Revision Notes

Changes to v13 (date:4/3/12)

: PowerCell-v13

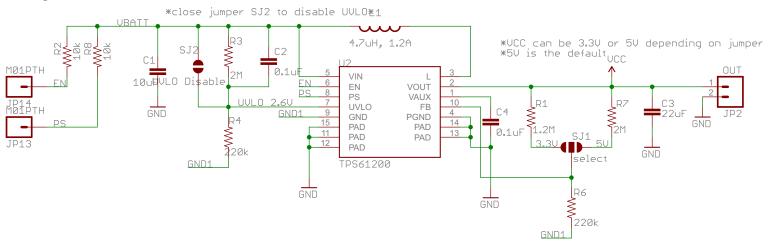
- -added breakout pins for PS and EN
 -Route traces on IC directly away from pads to prevent uneven reflow
 -move vias under IC so they're not as close to side ground pads
 -added jumper to disable UVLO
